DRAWING AND SPECIFICATION TRANSMITTAL
 LOCKWOOD GREENE ENGINEERS, INC.

DATE July 23, 1980
 JOB NO. 77239.16
 JOB NAME Naval Regional Medical Center

SUBJ: Items X-5300, X-5301, X-5302,
Transmittal No. 611-616

Subj: X-ray Film Processing Equipment

XONICS HI CAP PROCESSOR

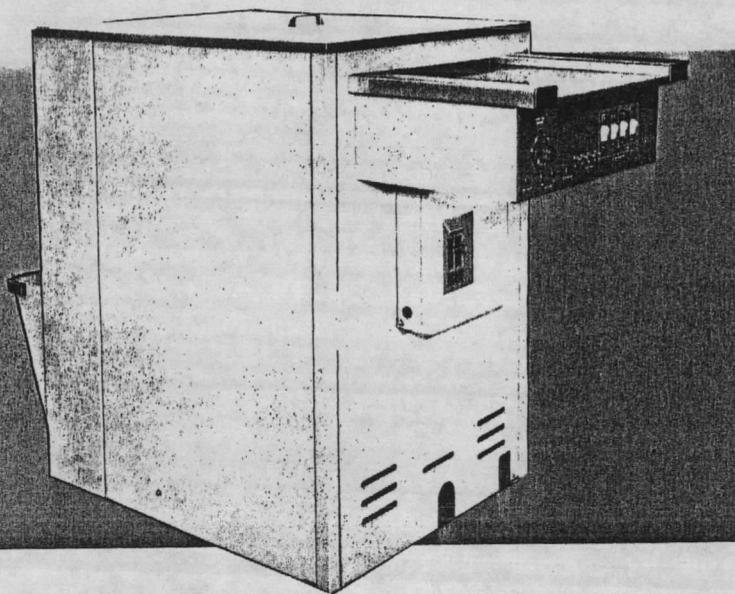
SEE 11757-715, 716 & 719 FOR
REQ'D FEATURES
